## Comment #91 D2.2

Missing INRUSH state

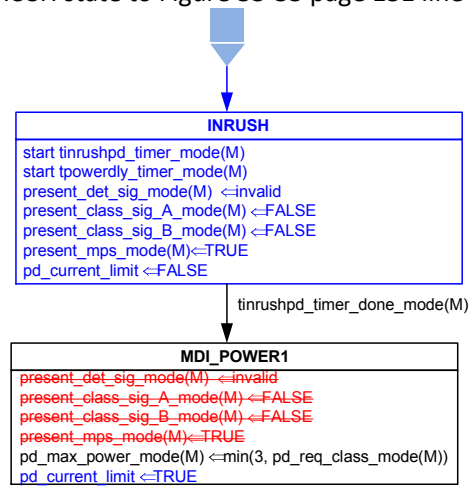
1. In page 150, line 51: Change the exit label name from MDI\_POWER1 to INRUSH
2. Delete editor note in page 151 lines 5-6.
3. Add to following INRUSH state to Figure 33-33 page 151 line 7 as follows:

### Add the following variable:

pd\_current\_limit\_mode(M)

Control on Mode M limiting the input current to a value conforming to  $I_{inrush\_PD-2P}$ , as defined in Table 33-30.

Values:

FALSE: The PD is not required to control the input current.

TRUE: The PD is required to control the input current.
